UNITED STATES PATENT AND TRADEMARK OFFICE

10/533,030

Office Action Summary

DETAILED ACTION

本発明の工程説明図 Procedure Diagrams of Present Invention

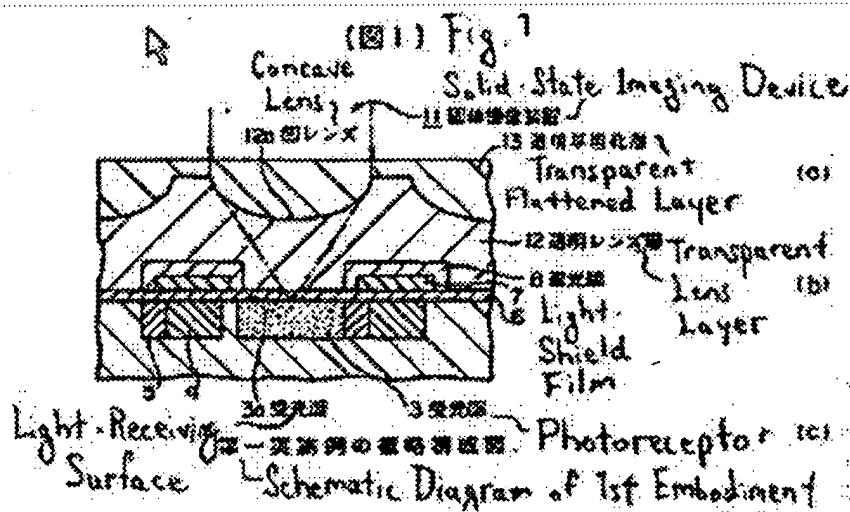
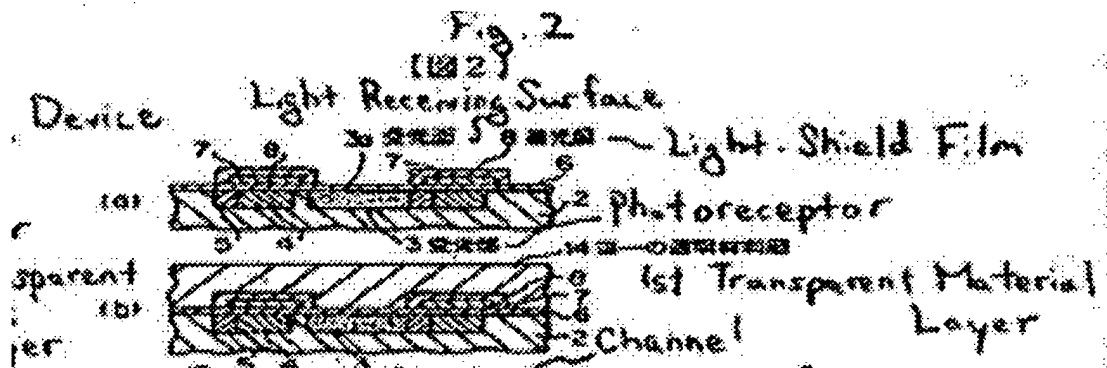
6. As for claim 5, Suzuki discloses and shows in Figs. 1, 2c, and 2f a method of manufacturing a solid state imaging device comprising:

- a. an insulating film (12/14) etching step for etching a fiat light transmitting insulating film along a predetermined mask pattern to form convex regions between adjacent micro lenses (Suzuki discloses (Pages 10 – 12, [0017] - [0018]) the use of etching to create the convex form of the layer);
- b. a lens film laminating step for laminating a light transmitting lens film (13) on the insulating film; and;
- c. an etching step by etch back processing of the lens film (Suzuki discloses (Pages 10 – 11, [0017] – [0018]) that the flattening process of layer 17, which is also applied to the layer 13, is done by etching the same).

7. Suzuki fails to disclose the creation of concave regions over the convex regions when flattening the lens film (13).

FIG. 6 (c)

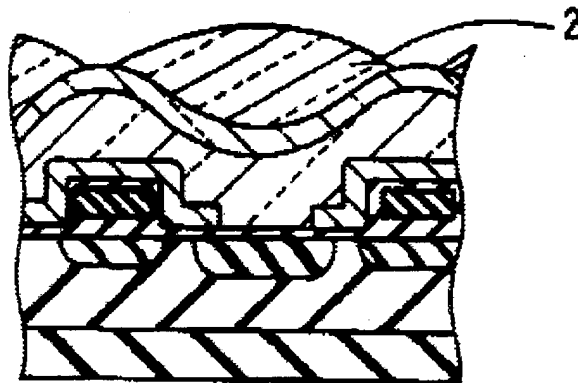
8. Sano discloses (Col. 11, lines 15 – 30) and shows in Fig. 6(a) – 6(c) the method of crating a concave lens (2) on top of a convex region in a solid state imaging device by etching.

9. Sano is evidence that ordinary workers in the art would find a reason, suggestion or motivation to create a concave lens on top of the convex region of the solid state imaging device.

FIG. 3

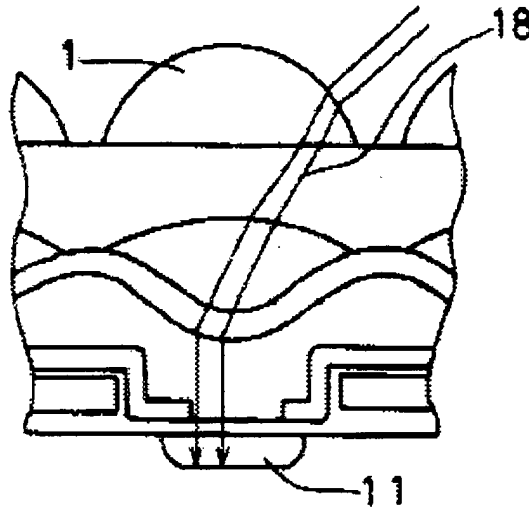
10. Therefore, it would have been obvious to one of ordinary skill in the art at the time of the invention was made to modify Suzuki by etching the flattening layer (13) all the way until creating a concave lens on top of the convex region of the solid state imaging device for advantages such as improving the sensitivity of the structure when the diaphragm of the optical lens is open (Col. 12, lines 3 – 7) as shown in Fig. 3.
